# **NORTHWEST ASSOCIATED CONSULTANTS, INC.**

## **MEMORANDUM**

TO: Phil Kern  
FROM: Alan Brixius  
DATE: May 8, 2024  
RE: Delano - Parkview Hills North - 2024 Preliminary Plat / Final  
FILE NO: 432.07 - 24.04

GRADING  
PLAN  
C3-1

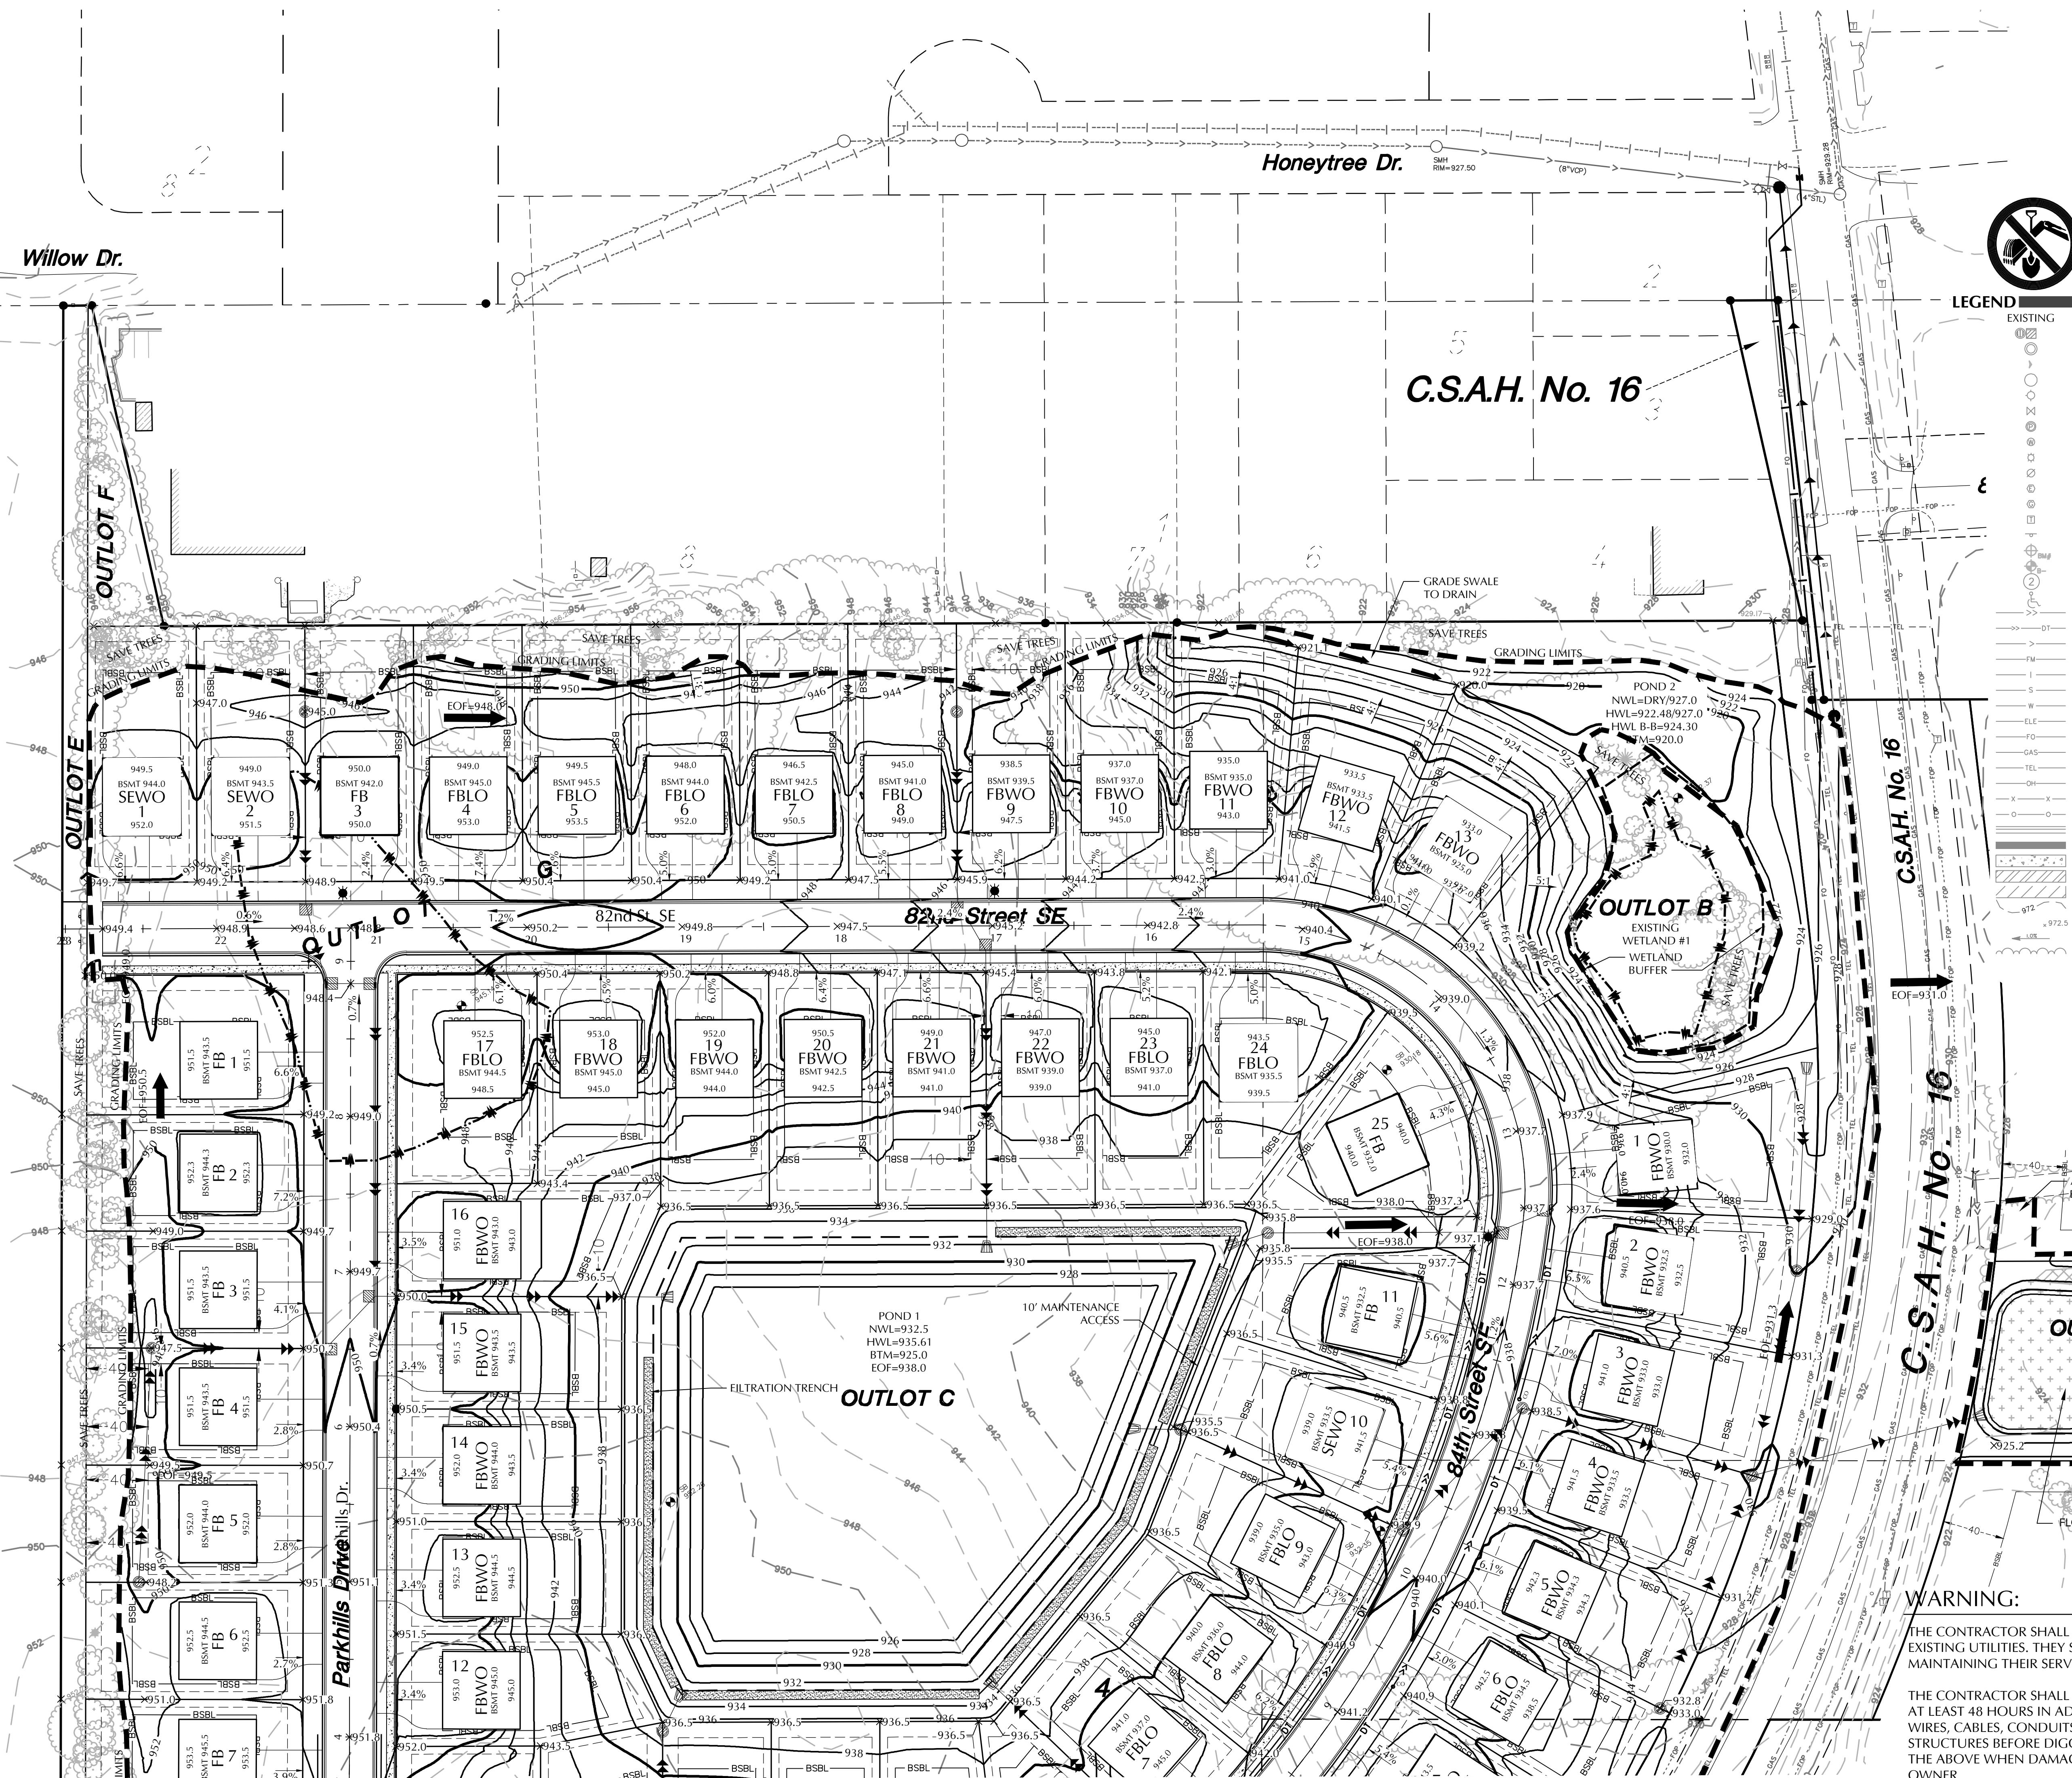
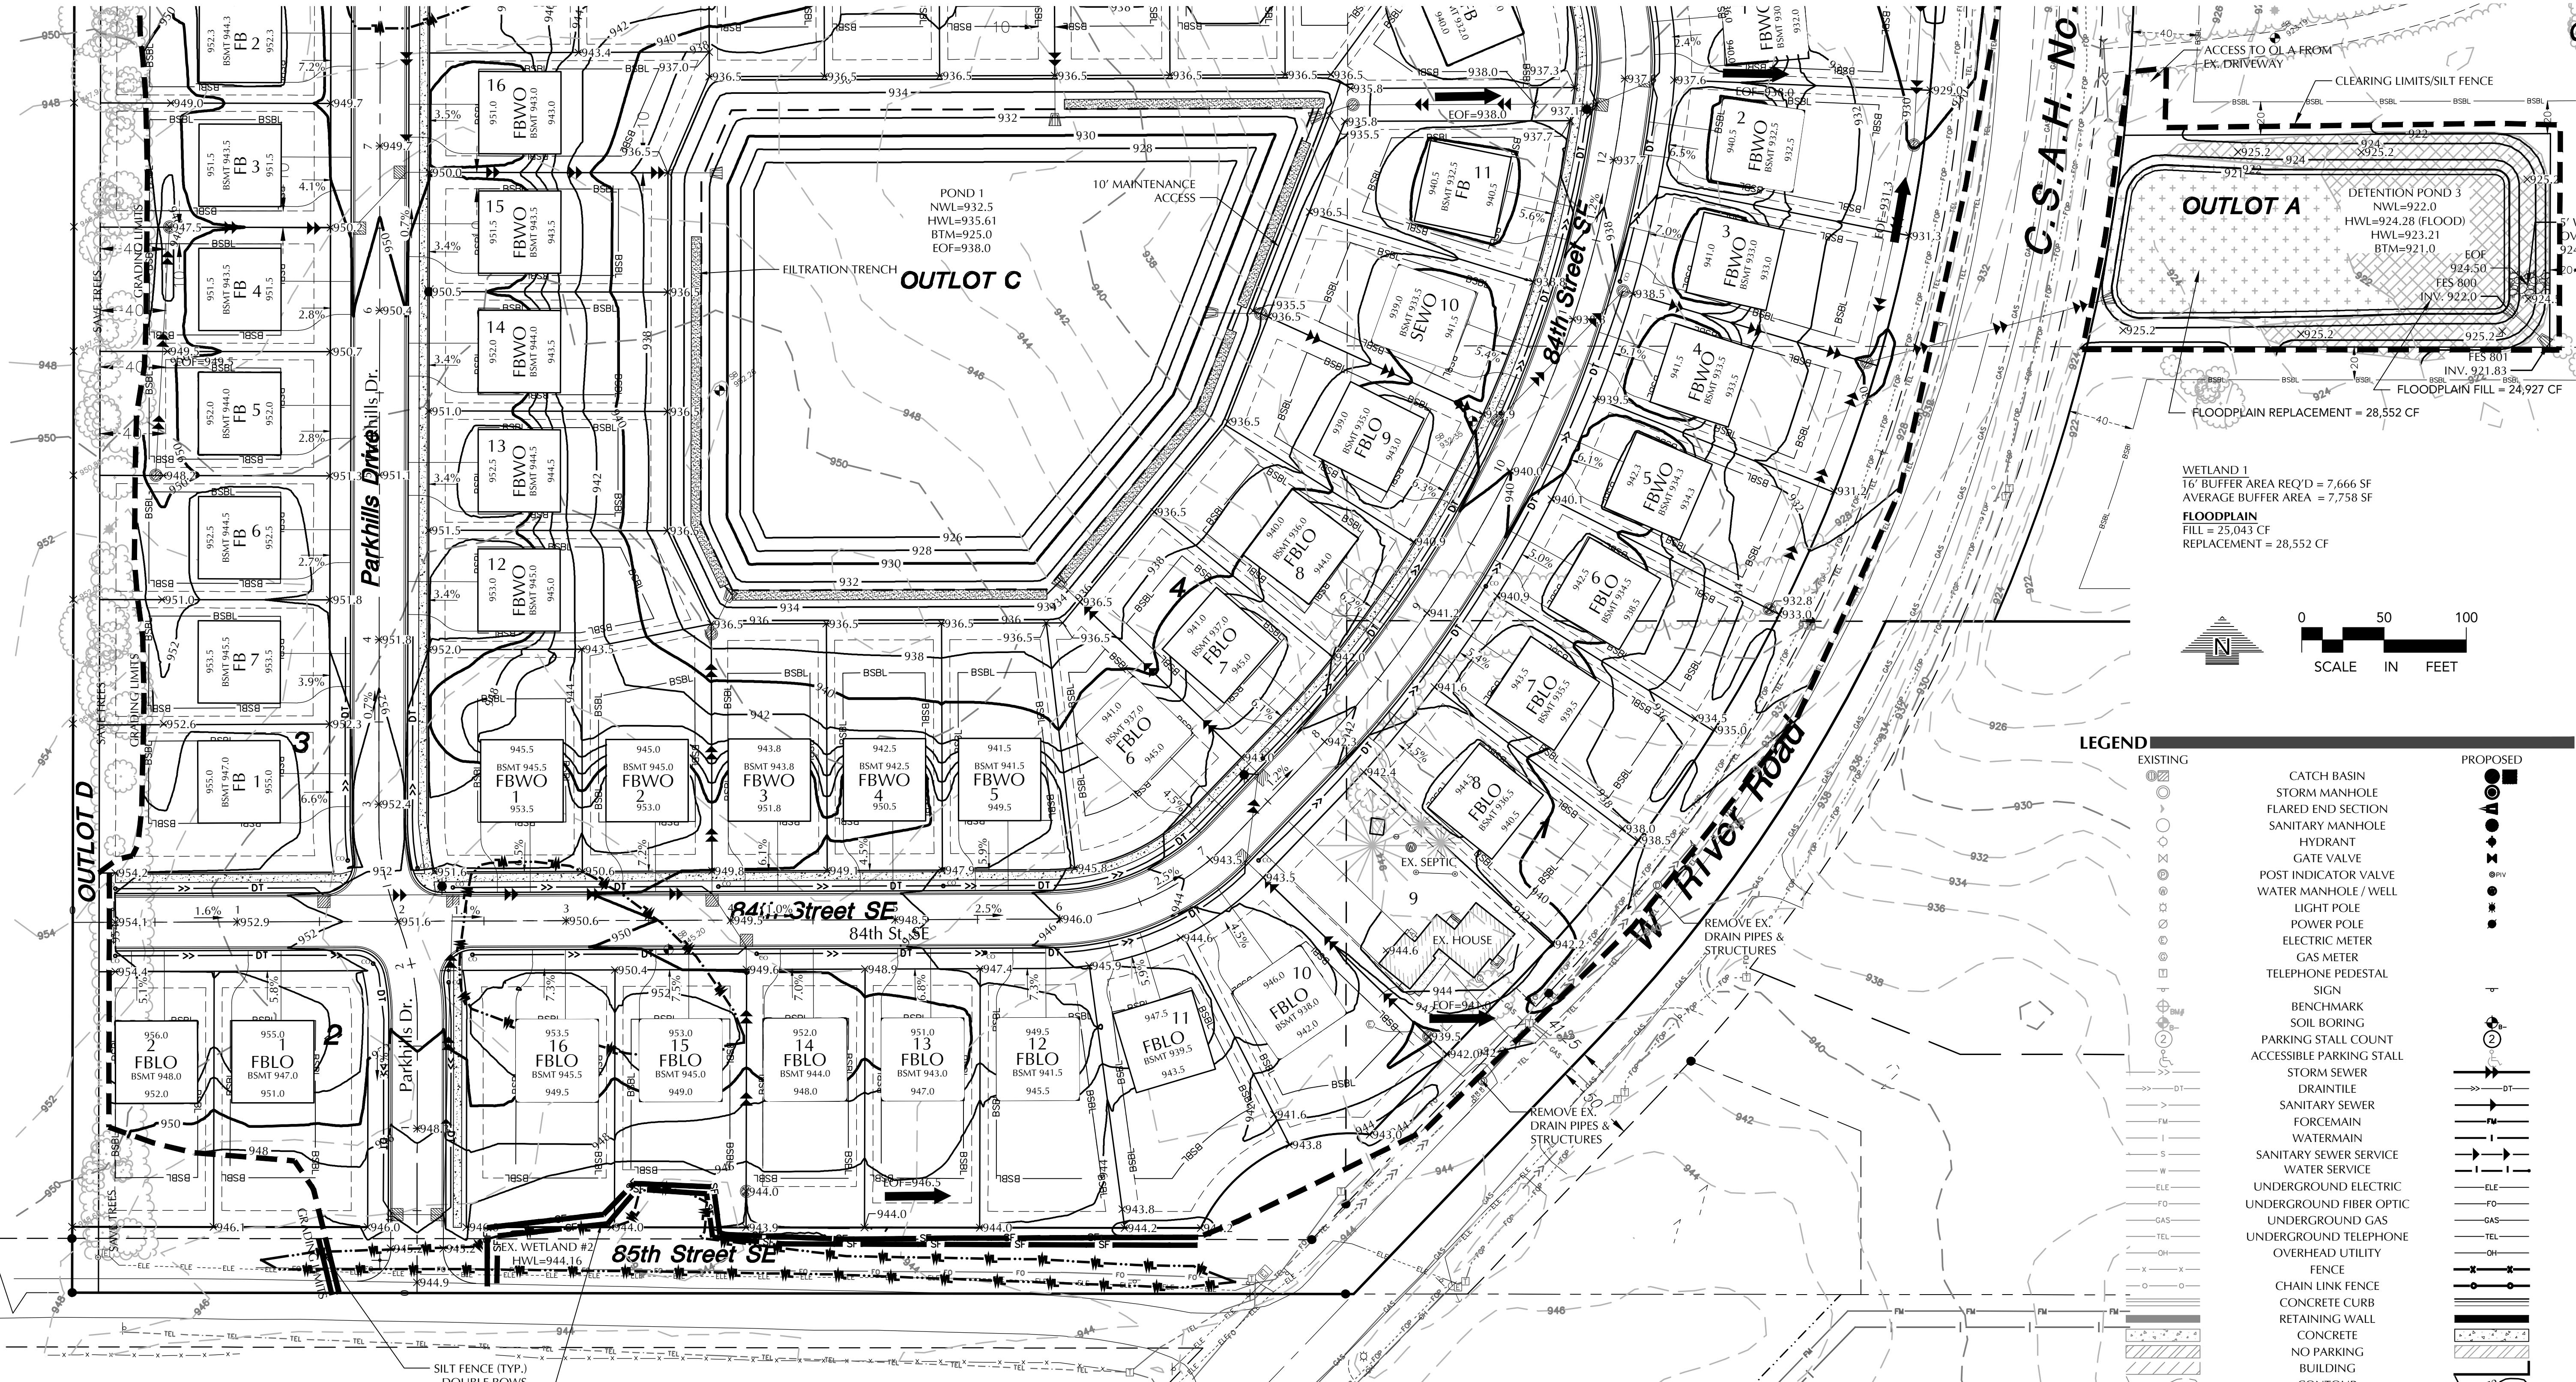
Lots in Block 6 and 7 all exceed the lot size standards. These lots have additional lot depth in an effort to preserve trees along the west and north plat boundaries. The Grading plan (Exhibit E) shows drainage swales across rear lots to catch basins. The location of these swales runs through the rear yards of these lots between the building pads and the tree preservation area. These swales must be located within a drainage and utility easement to prevent alterations that may impede the approved drainage patterns. The swale and easement will limit the ability to use the rear yard. No sheds, decks, fences, or filling may be allowed within the easement that may obstruct the approved drainage patterns in Block 6 and 7. The plat must be revised to establish the needed drainage and utility easement over the drainage swale. As a condition of plat approval easement restrictions shall be included as deed covenants and in the sales materials for these impacted lots.

1. The grading plan shows a storm sewer along the rear lot lines of lot 1 – 5. This will not allow buffer yard plantings within the lots.
2. The Landscape plan shows the buffer yard planting within County Road 16 right-of-way. This is not acceptable in that the landscaping is outside the plat.
3. The house pad will be 2 to 4 feet higher than the rear lot line elevation. This will reduce the effectiveness of the 6-foot-tall coniferous trees as screen.

In review of the grading plan, we recommend expanded easements must be placed over drainage swales located within the rear yards of Blocks 6 and 7 to preserve the proposed rear yard drainage patterns of the lots within these Blocks. Individual lot improvements cannot interrupt the rear yard drainage patterns to the detriment of the adjoining properties.

1. The grading, drainage, stormwater management, and erosion control plans shall be subject to the review of the City Engineer.
2. The grading plan indicates that house elevations are a minimum of 18 inches above the street curb. Homes must be located two feet above pond elevations, high water elevations, and one-foot above emergency overflows for low openings.
3. The submitted landscape plan must specify the following stormwater-related items:
  - Outlot, wetland, pond easement demarcation posts at the periphery of these outlots and easements to prevent trespass, mowing or buildings encroaching into these Outlots, stormwater drainage ways or ponds.
  - Tree preservation fencing shall be installed prior to the start of grading. The type, location and installation of the tree preservation fencing shall be approved by the City Engineer prior to initiating grading.

1. The Storm sewer shall be shifted to the rear lot lines of Block 1.
2. All buffer yard landscaping shall be located within the rear yards of the lots. Maintenance of the landscaped buffer yards shall be the responsibility of the future lot owners.
3. Landscaping shall be coordinated with the grading plan to maximize the screen effectiveness.
4. Drainage and utility easements shall cover the rear yard drainage swales.

13. The submitted preliminary and final plats shall be revised to illustrate all easements. Easements shall be placed over rear yard drainage swales. All easements shall be subject to review and approval of the City Engineer. No construction of sheds, fences, patios or filling may occur with the drainage and utility easements.
